**RE: SUPPLEMENTAL INFORMATION REQUESTS - ALBERTA SULPHUR
TERMINALS SULPHUR FORMING AND SHIPPING FACILITY**

This letter provides responses to the Supplemental Information Requests (SIR's) included in your letter of January 4th, 2008. For ease of reference, each question is reiterated in italics prior to providing the supplemental information.

Figure 150-1: Location of residences within the Call Out Zone

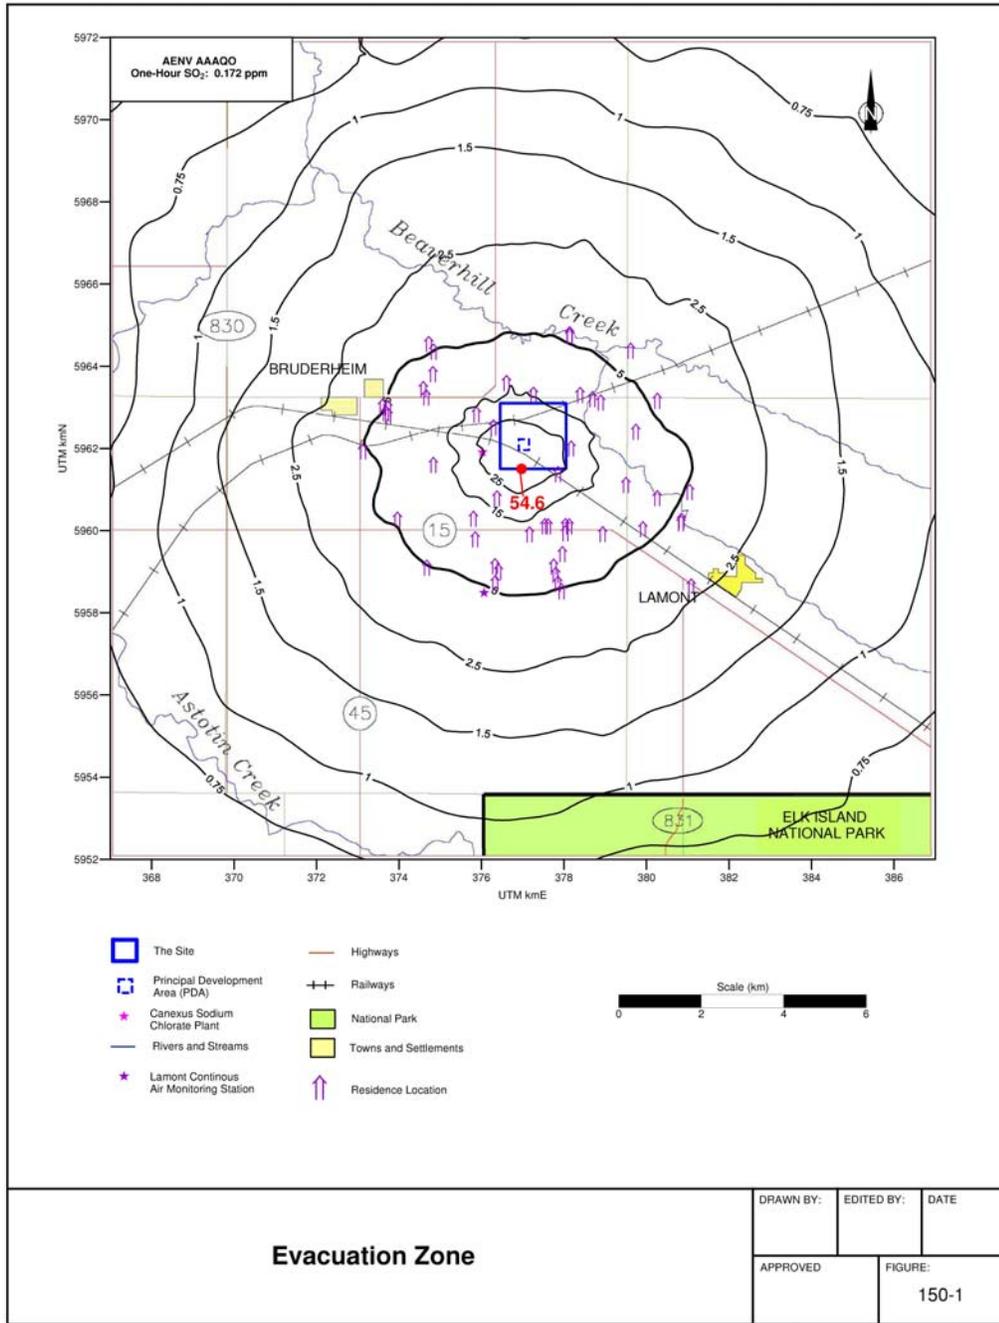
- c) *How will the different planning zones (i.e. the EUB's 'Emergency Planning Zone', 'Emergency Awareness Zone', 'Initial Isolation Zone', and 'Protective Action Zone') for specific incidents be referenced? Outline the specific actions and considerations for each zone.*

- A. Figure 150-1 shows the locations of residences within the Call Out Zone. Table 150-1 provides a partial list of landowners located within the Call Out Zone based on information gathered from the 2006 Lamont County Ownership Map. A complete list of landowners and residences located within the Call Out Zone for Worst-Case Scenario – SO₂ Release of 5 ppm will be compiled when the Final Emergency Response Plan is developed for the Project. The residences will be registered with the NR CAER Automated Emergency Dial-out Program.

Figure V-1: Evacuation Zone

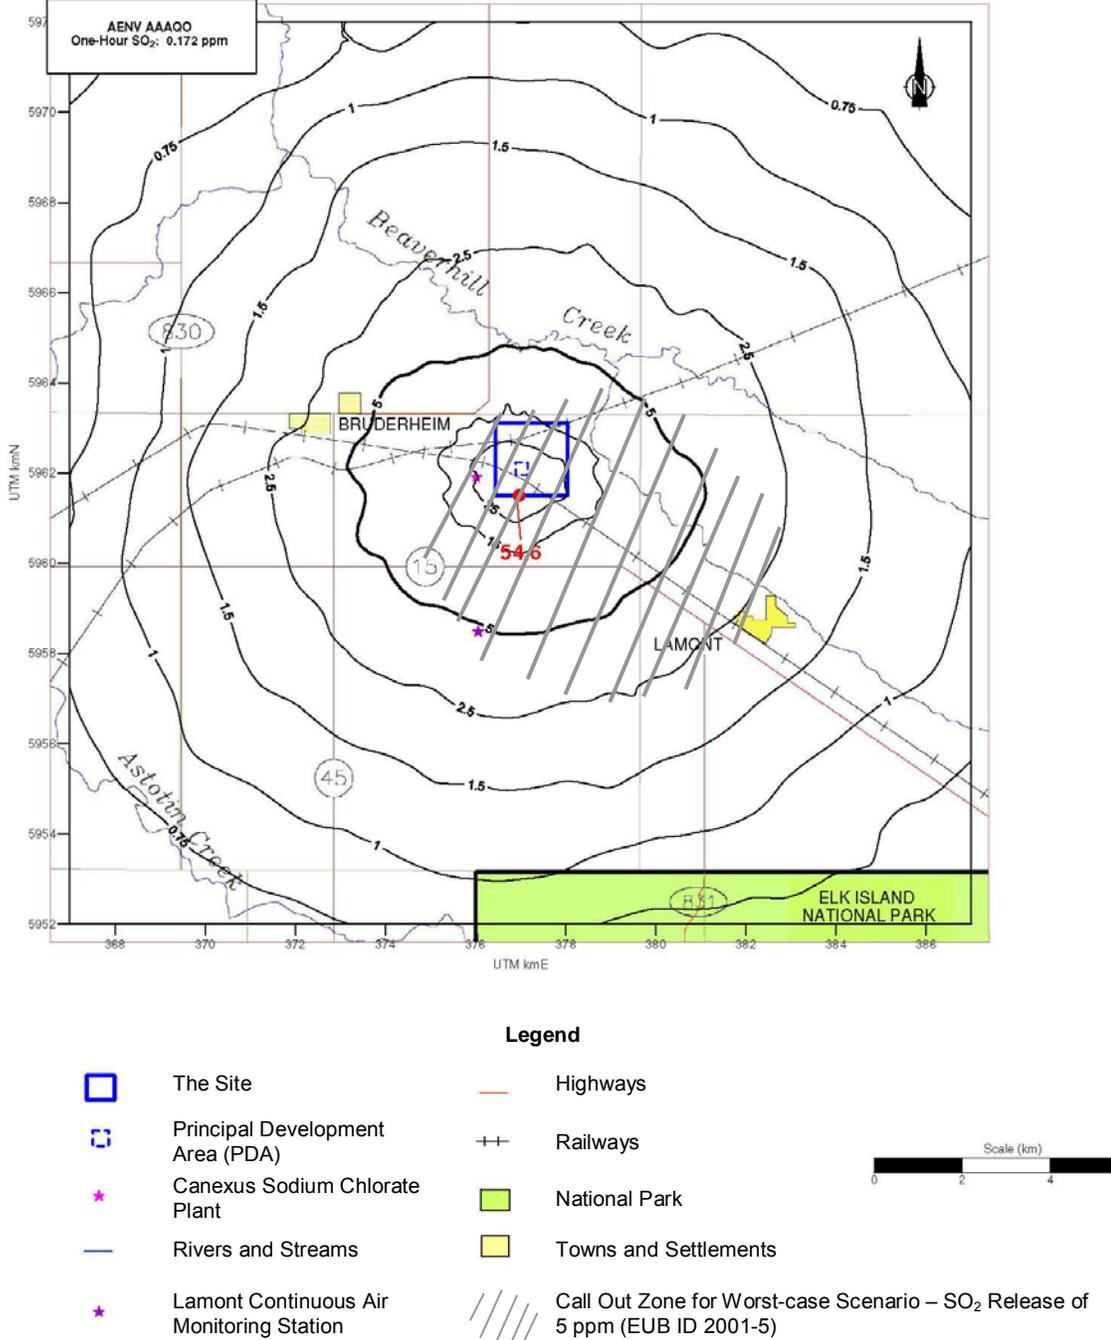
150. Volume I, Appendix V, Figure V-1, Page V-3.

- i) Emergency Planning Zone (EPZ): the evacuation zone associated with the worst case scenario as shown in Figure V-1 will be designated the EPZ . Modifications to the EPZ will be considered based on information gathered during the Public Involvement process to be conducted if the Project is approved and when the final ERP is drafted and submitted for approval.
